# City of Oregon City

## Meeting Agenda Planning Commission

GLUA-19-00001 (General Land Use Application), PARK-19-00001 (Parking Adjustment) SP-19-00007 (Site Plan and Design Review), and MP-19-00001 (Minor Partition) for 221 and 202 Molalla Avenue

**FILE NUMBER:** GLUA-19-00001 (General Land Use Application), PARK-19-00001 (Parking Adjustment)  
SP-19-00007 (Site Plan and Design Review), MP-19-00001 (Minor Partition)

Figure 3: Proposed Site Plan

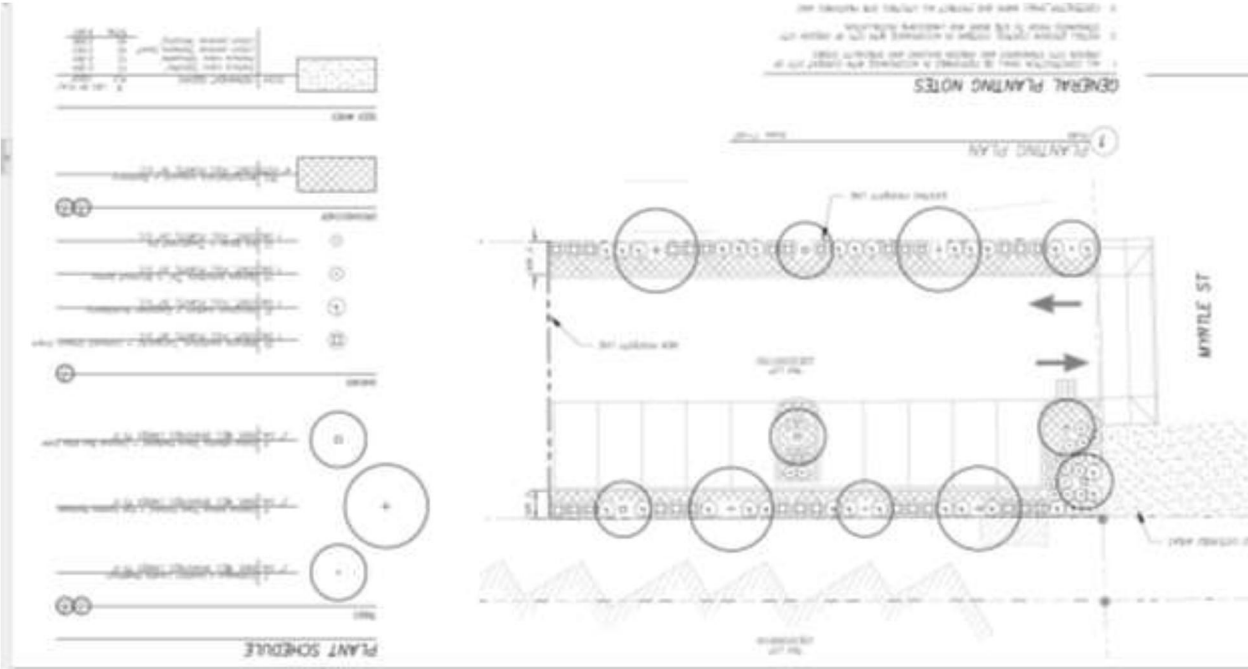
**Finding: Complies as Proposed.** The applicant has requested a modification to OCMC 17.52.040 Parking lot landscaping. The applicant requests that the requirement for the 5-foot perimeter landscaping be waived along the shared rear property line. The request is made in order to retain 10 parking stalls and maintain a safe turning radius for the stall closest to the driveway entrance. Installing the perimeter landscaping in this location would cause the project to lose a parking space in the design or reduce the turning radius for the front parking space below code standards.

Concentrating more robust landscaping along the longer, 100- foot-long side property lines, in lieu of the rear property line, still enables the project to enhance and soften the appearance of the parking lot and provide an equivalent level of pollution reduction and shading of parking areas. The alternative proposal also limits the visual impact of the vehicle area on adjacent properties and right-of-ways along the other three property lines.

Figure 2: Site Plan

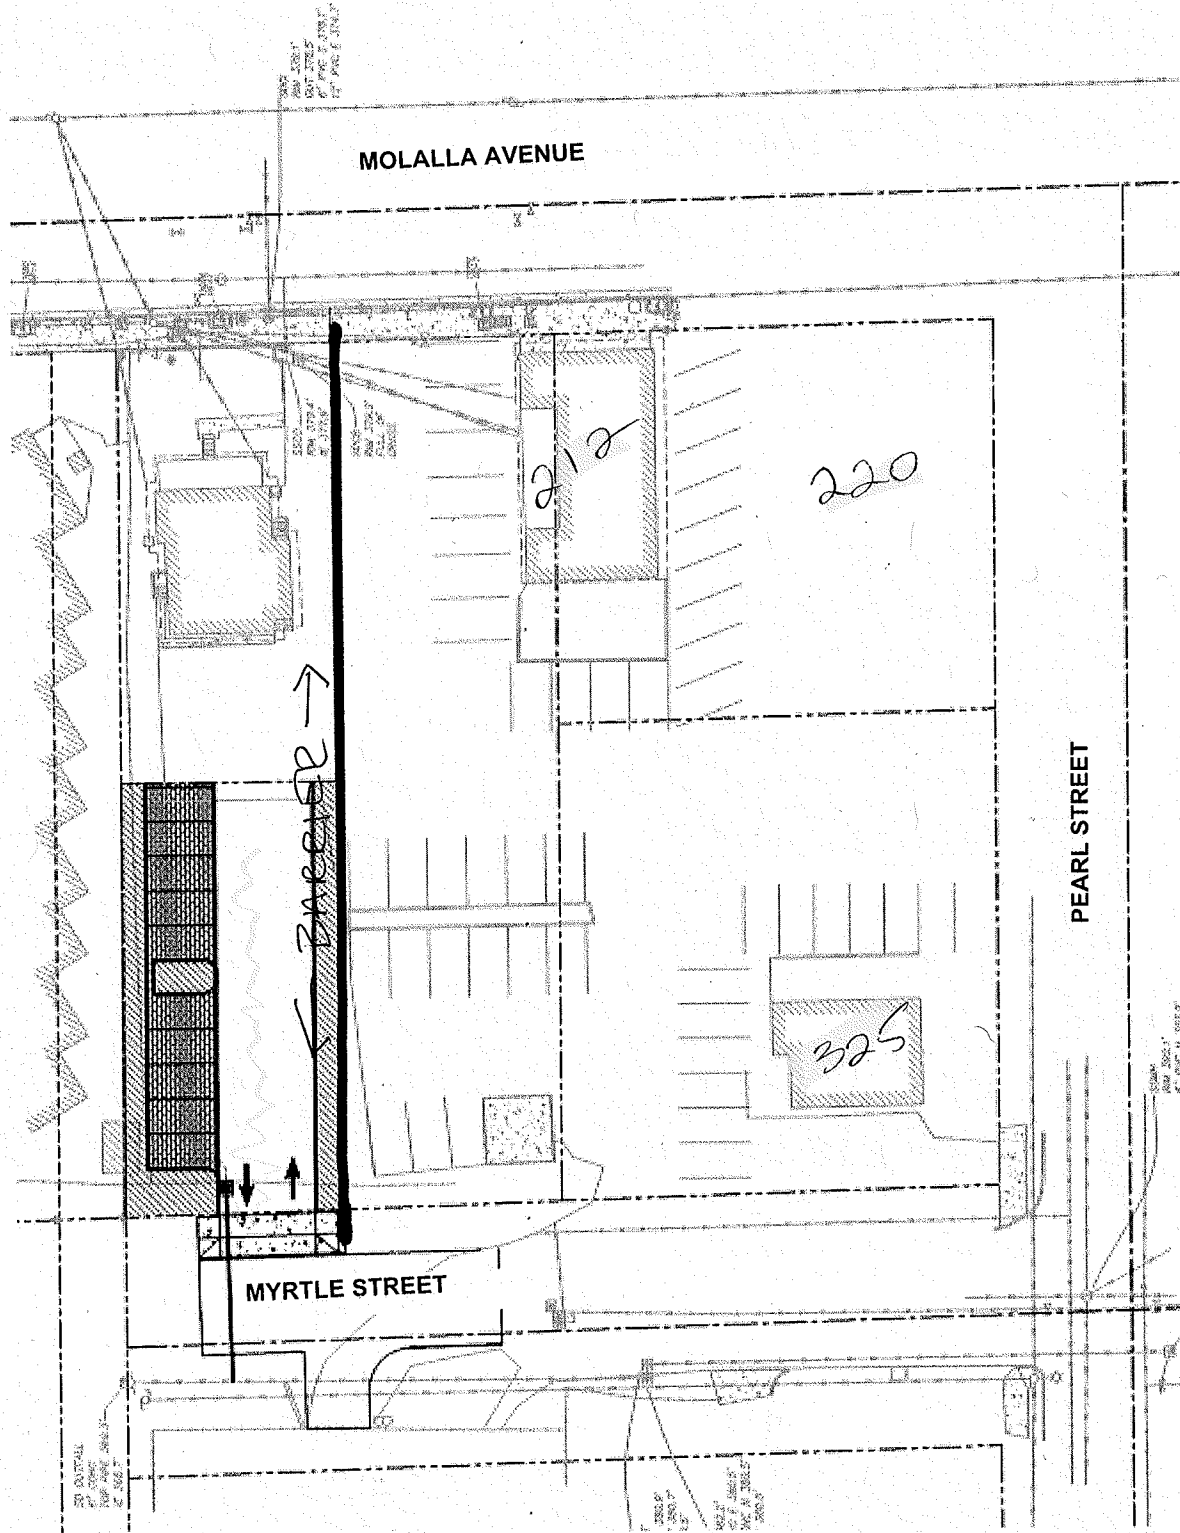
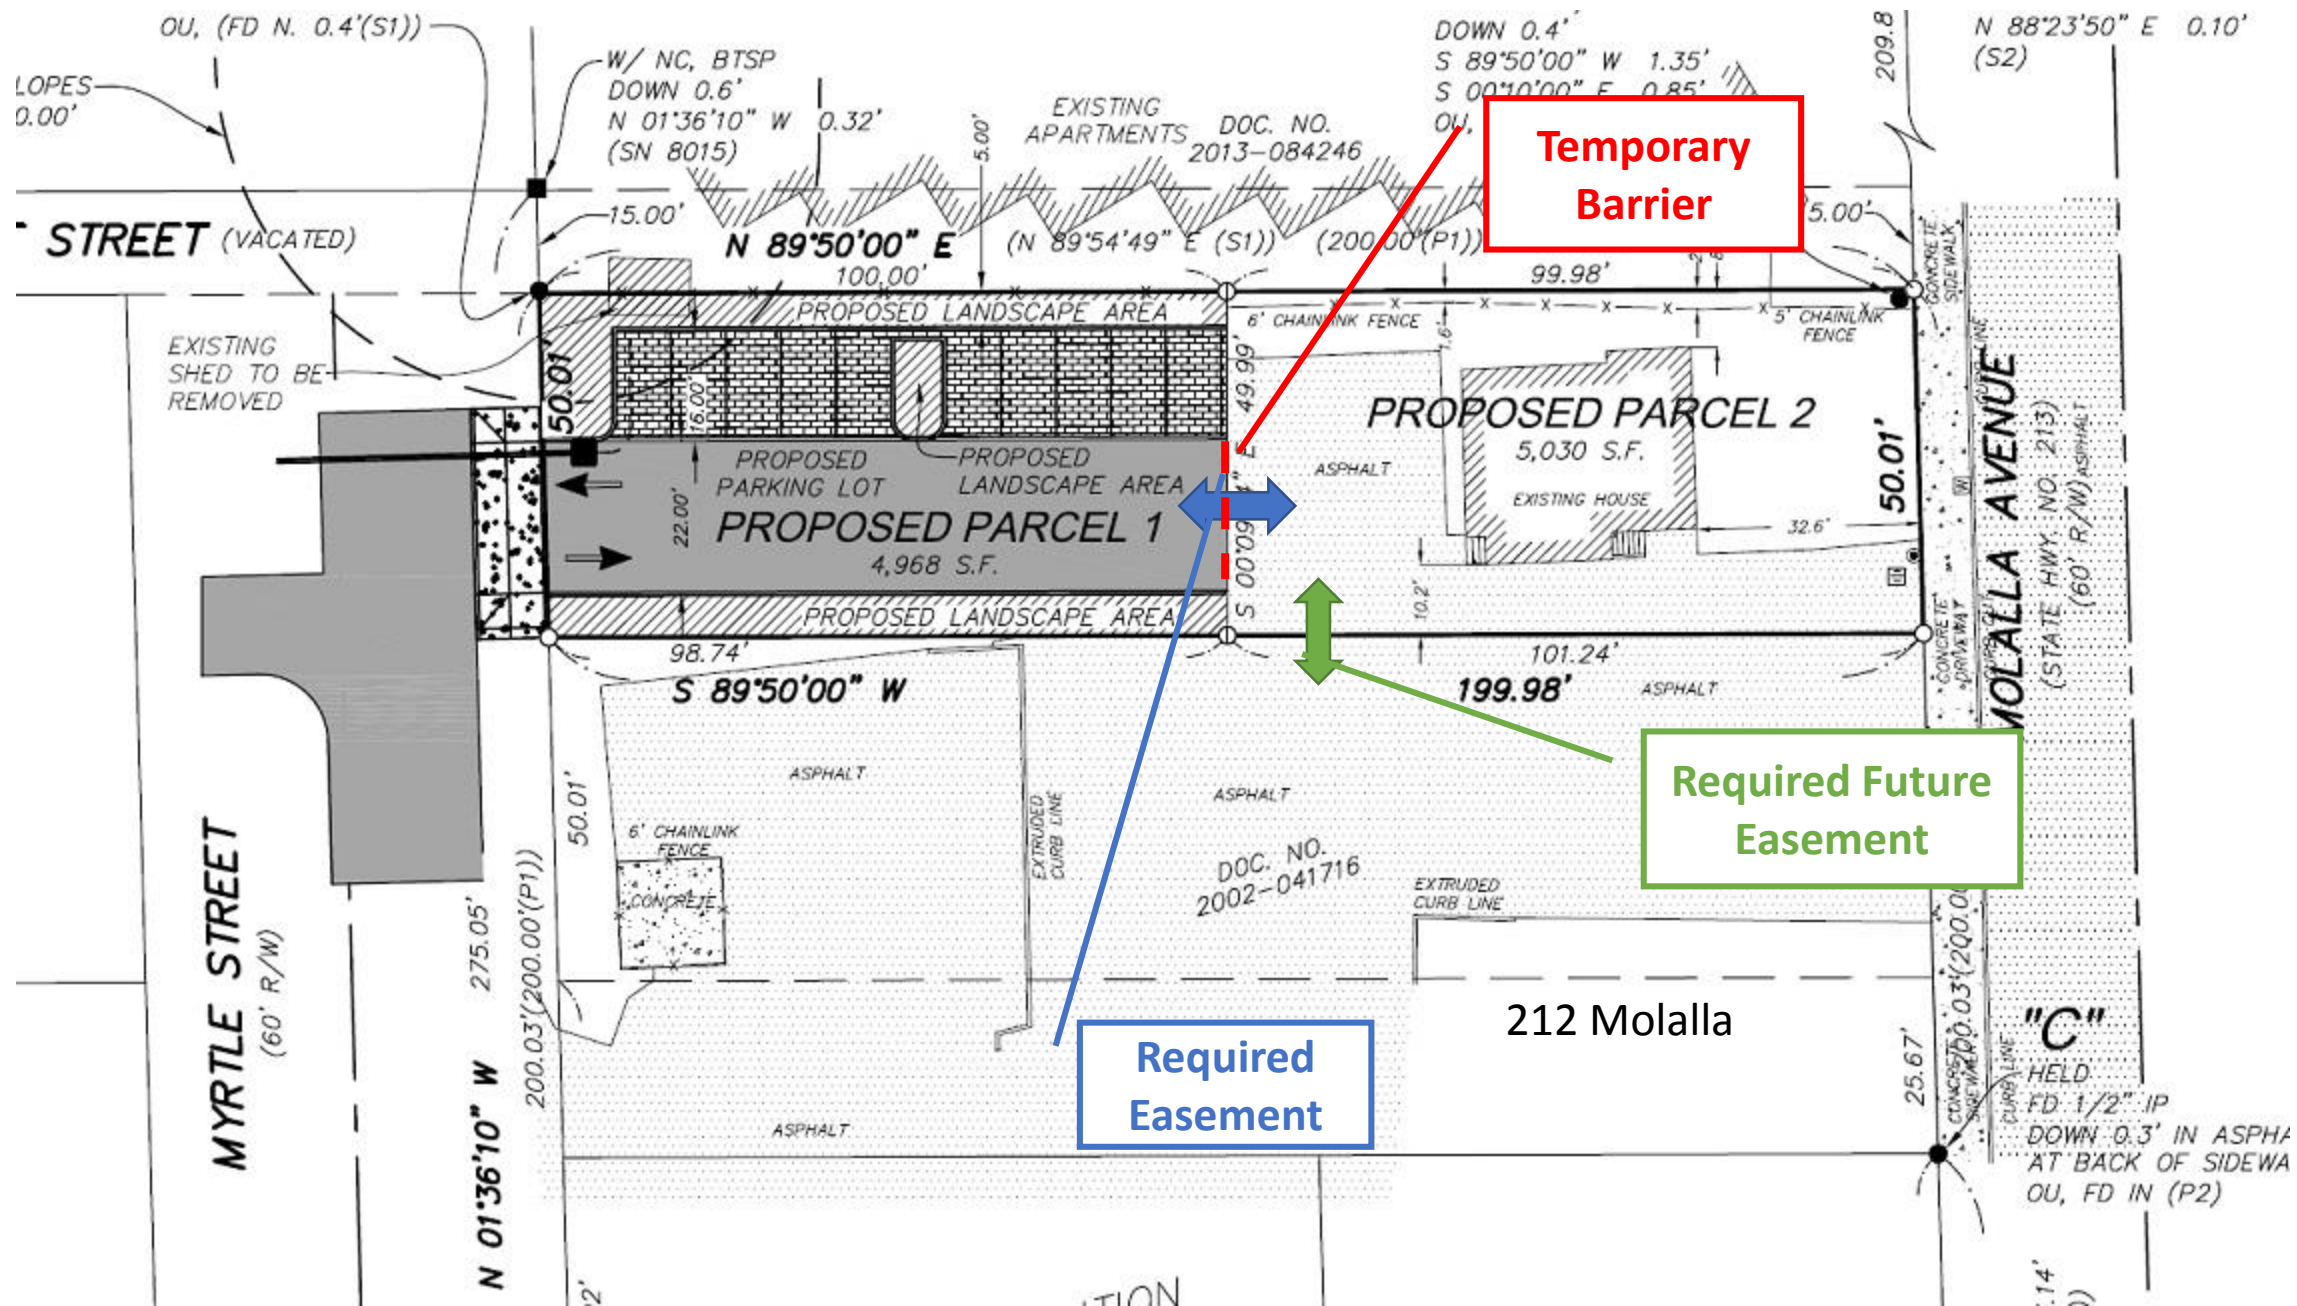
I find that the TAL meets city requirements and provides an adequate basis upon which impacts of the proposed parking lot can be assessed.

The TAL identified no safety issues. The driveway location, width and spacing meet applicable standards. Traffic to and from the site will be minor. I conclude there is little, if any, impact to the transportation system from this proposal and I find no need for transportation improvements to mitigate for the transportation impacts of this development.
